ALERT SERVICE BULLETIN ASB No. AA-06179

Revision A

Emergency Pushout Window

P/N 407-561-113 / 407-561-114 / 407-561-121 /

FIGURE 3 - PUSH BLOCK POSITIONS FOR INITIAL EVALUATION

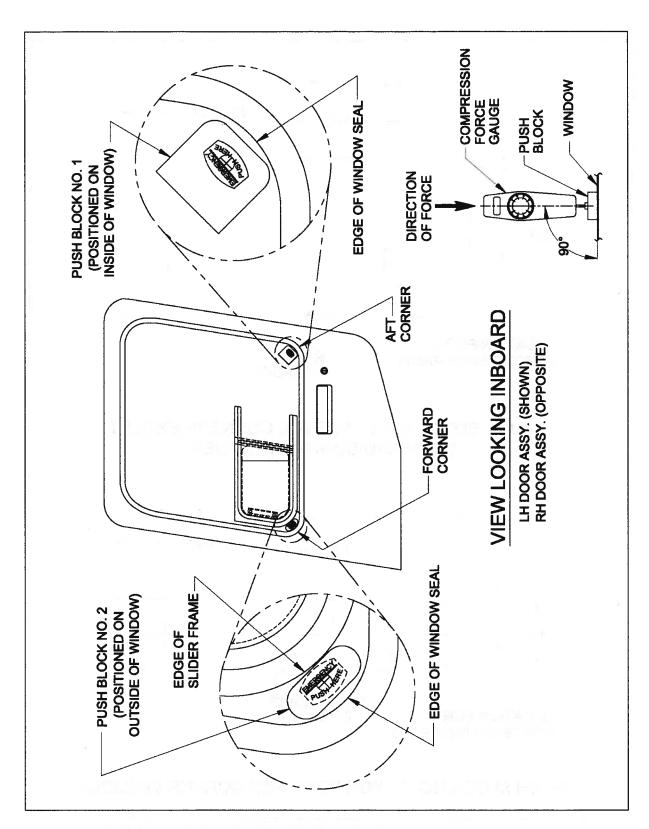
- 6. From the lower inside aft corner of the window gradually apply force, perpendicular to the window, to the center of the "Emergency, Push Here" decal that is located in that corner (see Figure 3).

1. From the lower outside forward corner of the window, gradually apply force, perpendicular to the window, to the center of the "Emergency, Push Here" decal that is located in that corner (see Figure 3).

FIGURE 4 – WINDOW MODIFICATION

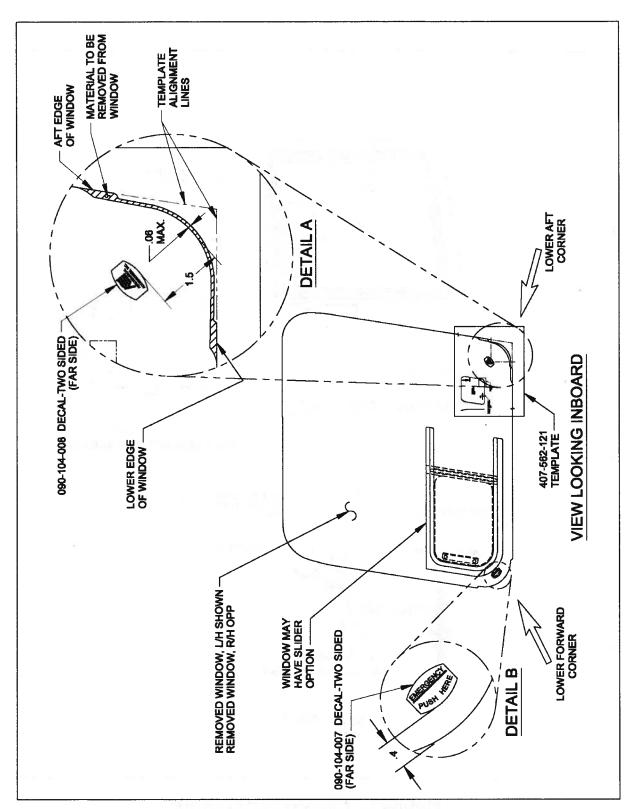
1. Carefully lay the window on a horizontal work area that will not scratch or damage the surface. Orient the Template (407-562-121) in the lower aft corner of the window by aligning the alignment lines on the template with the aft and lower edges of the window, as shown in Figure 4 – Detail A.

Verify the amount of window material that extends past the radial portion of the template radius does not exceed .06 inches (ref. Figure 4 – Detail A).

If window material does not extend past the radial portion of the template radius, the window does not require modification; proceed to Section 5. Otherwise continue with Step 2.

2. Mark the new corner profile from the template onto the surface of the window with a fine tip felt marker. Remove excess window material according to the new profile, using a medium grit abrasive pad (80 – 100 grit).

- 1. Remove existing "Emergency Push Here" decals (090-104-002) from the lower, inside corners of the window. Remove all remaining adhesive from the window using isopropyl alcohol.
- 2. Apply Decal Two Sided (090-104-007) to the forward lower, inside corner of window as shown in Figure 4– Detail B. Apply Decal Two Sided (090-104-008) to the aft lower, inside corner of window as shown in Figure 4 Detail A.
- 3. Window decal replacement complete.

FIGURE 5 - WINDOW INSTALLATION

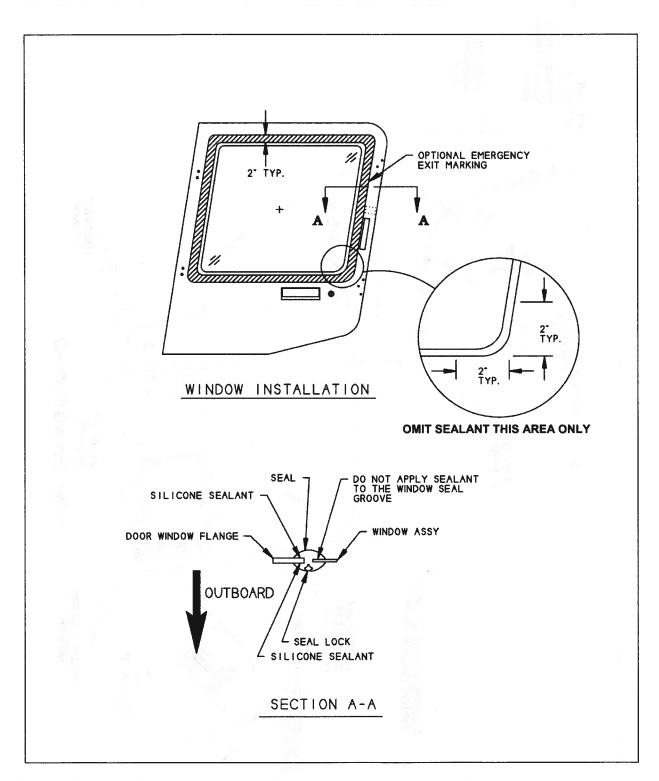
- 14. Using Syringe (099-859-002), apply Sealant (099-050-243) to both sides of the narrow seal groove except in lower aft corner area, as shown in Figure 5, and to the areas of the window frame that have been prepared for bonding.

FIGURE 6 - SEAL LOCK (FILLER) INSTALLATION

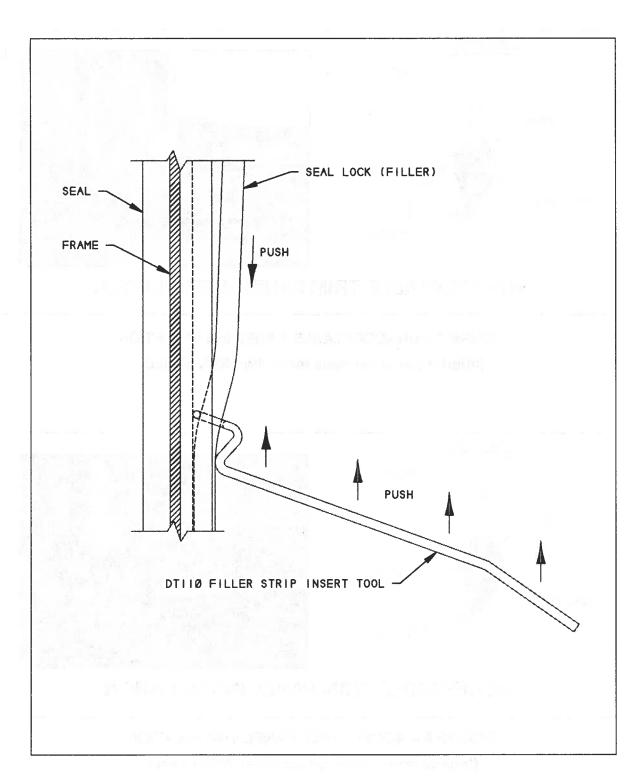
- 11. Install seal in window frame. Masking tape may be used to temporarily hold the seal in place for the next step. Verify seal is fully seated into window frame corners.
- 12. Place the window in the seal groove and work seal lip around outside edge of window.
- 13. Starting at the 12 o'clock position, install provided Seal Lock (407-210-103) into seal insert groove using provided Filler Strip Insert Tool (DT110), while pushing the seal lock through the tool to keep it from stretching (see Figure 6). Seal lock is precut to proper length, do not trim. Work seal lock around until it fits properly.

FIGURE 7 – UNACCEPTABLE PANEL INSTALLATION (Interior panel overlaps more than 50% of seal)

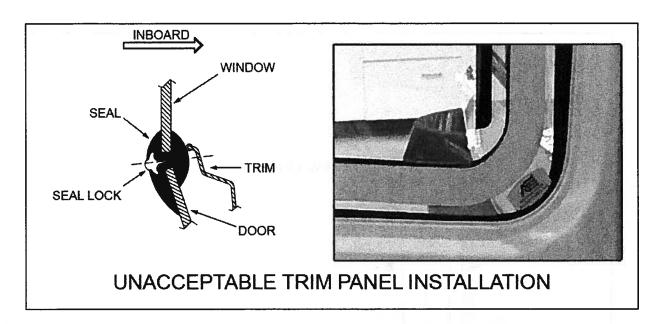
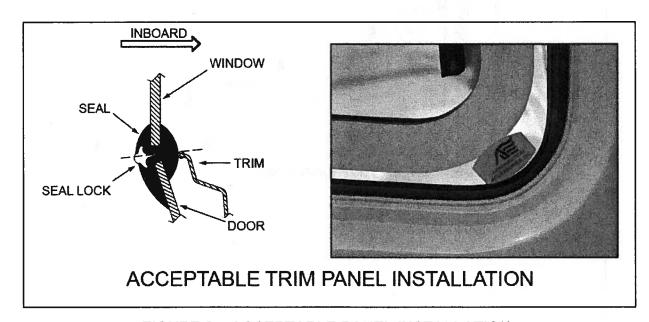
- 1. If installed, verify the upper interior door trim panel does not overlap the seal more than 50% (see Figures 7 and 8). If the overlap exceeds 50%, remove the upper interior door trim panel and trim the material until the overlap on the seal is less than 50%. Reinstall the upper interior door trim panel before proceeding.
- 2. From the lower outside forward corner of the window, gradually apply force, perpendicular to the window, to the center of the "Emergency, Push Here" decal that is located in that corner (see Figure 3).

- 15. Remove all masking tape and allow sealant to cure for a minimum of 24 hours at 75 degrees Fahrenheit (24 degrees Celsius).
- 16. Reinstall upper interior door trim panel, if previously removed, ensuring the inside edge of the upper interior door trim panel is adequately trimmed for seal to function correctly. A minimum of one-half of the seal flange width must be exposed around the perimeter (see Figures 7 and 8).
